MEMORANDUM

To: Tim Pearson, Conservation Agent
From: James Thorne, PE, Business Manager IV
Sam Spelman, Scientist II
Date: August 27, 2025
Project Name: Littleton CC – 550 King Street Peer Review
Project Number: Green No. 25008.05XX
Subject: Field Review and Investigation of the Wetland Delineation at 550 King Street, Littleton, MA

Figure 1: Recommended alteration to the A-Series BVW in red (addition of flags GIA-WF-119 and GIA-WF-120).

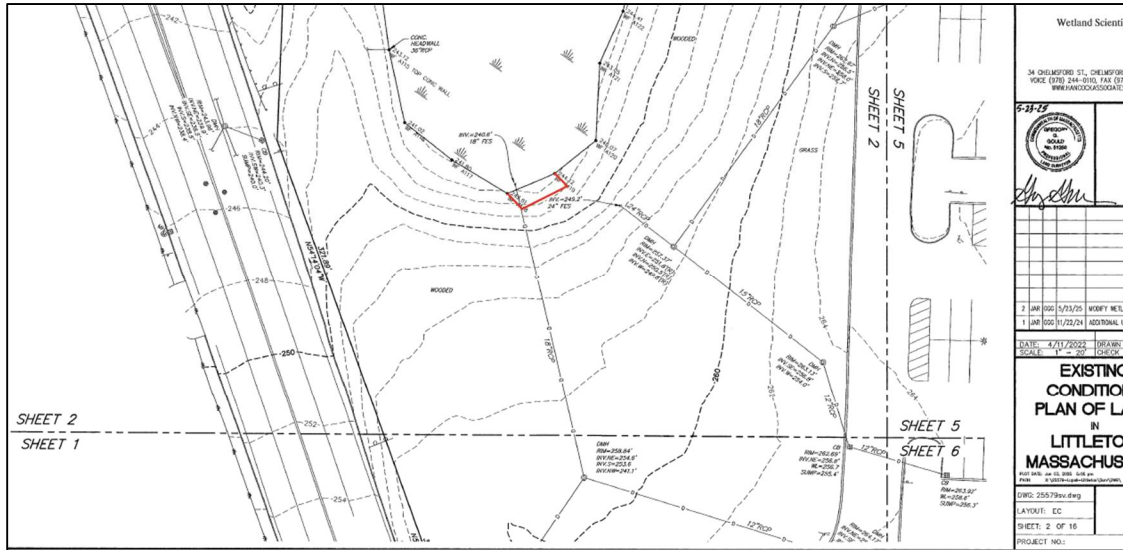
A forested area located to the south of wetland flags (WFs) #A118 and #A119 was identified as an upland area during Hancock Associates’ assessment. However, the vegetation community in this area was dominated by a number of hydrophytic plant species, including sensitive fern (*Onoclea sensibilis*), skunk cabbage (*Symplocarpus foetidus*), jewelweed (*Impatiens capensis*), reed canary grass (*Phalaris arundinacea*), and purple loosestrife (*Lythrum salicaria*). This area also contained strong evidence of hydrology, including soil saturation and a high water table. Hydric soil indicators were not encountered in this area; however, the soil profile at this location was heavily disturbed by fill material, likely explaining the uncharacteristic soils observed in this area. Despite the lack of hydric soils at this location, the abundance of hydrophytic vegetation and extensive hydrologic indicators has led our staff Wetland Scientist to conclude that this area should be classified as part of the A-Series BVW.

The staff Wetland Scientist’s recommendation is to extend the wetland boundary to include the above-referenced area, which has been flagged in the field with pink flags labeled “GIA-WF-A119 and GIA-WF-A120”. These new flags shift the BVW boundary approximately 10 feet south in the identified area. The Wetland Scientist’s disagreement with the resource area delineation concludes at Hancock Associates’ WF #A119, and they concur with the placement of the remainder of the A-Series boundary. Including

these additional flags will ensure that the aforementioned area is included as part of the BVW delineated by the A-Series.
